1994 Corvette: Service Bulletin: Garage Shift Delay Engagement (New Garage Shift Package)

Subject: Garage Shift Delay Engagement (New Garage Shift Package)

Bulletin Number: 47-71-20A

REVISION: 09/12/94

ORIGINAL GARAGE SHIFT PACKAGE

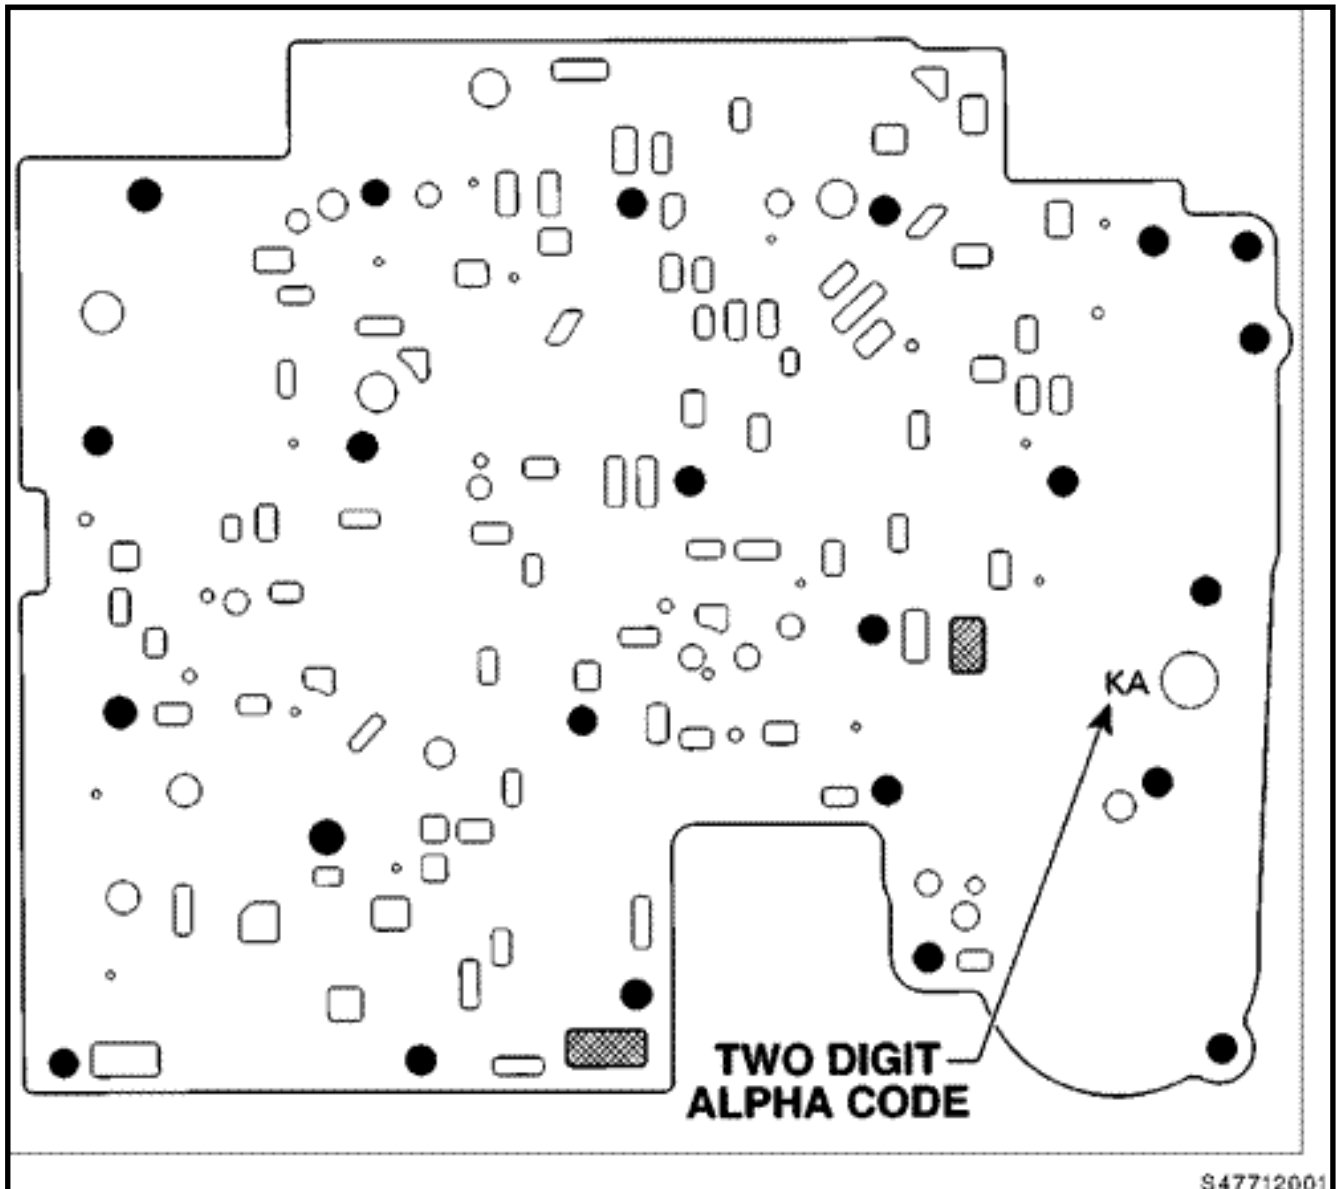
NOTE: THE TRANSMISSION SPACER PLATE MUST ALSO BE REPLACED WITH AN ENHANCED GARAGE SHIFT PACKAGE SPACER PLATE, CONSULT YOUR PARTS CATALOG FOR THE PROPER SPACER PLATE PART NUMBER.

WHEN PERFORMING ANY OTHER REPAIRS ON A 1994 VEHICLE EQUIPPED WITH A HYDRA-MATIC 4L60-E TRANSMISSION BUILT BEFORE MARCH 7, 1994 (JULIAN DATE 066), THE SPACER PLATE IDENTIFICATION MUST BE

CHECKED TO SEE IF THE TRANSMISSION HAS HAD A NEW GARAGE SHIFT PACKAGE INSTALLED TO BE SURE THE TRANSMISSION IS BEING SERVICED WITH THE PROPER PARTS. SEE THE FOLLOWING CHART FOR SPACER PLATE IDENTIFICATION.

THE NEW SPACER PLATES MUST BE USED WITH THE ENHANCED GARAGE SHIFT PACKAGE AND THE ORIGINAL SPACER PLATES MUST BE USED WITH THE ORIGINAL GARAGE SHIFT PACKAGE. THE SPACER PLATES AND GARAGE SHIFT PACKAGES ARE CALIBRATION SENSITIVE; MIXING SPACER PLATES AND GARAGE SHIFT PACKAGES MAY CAUSE PREMATURE FAILURE. WHEN A GARAGE SHIFT PACKAGE IS CHANGED, THE SPACER PLATE MUST ALSO BE CHANGED.
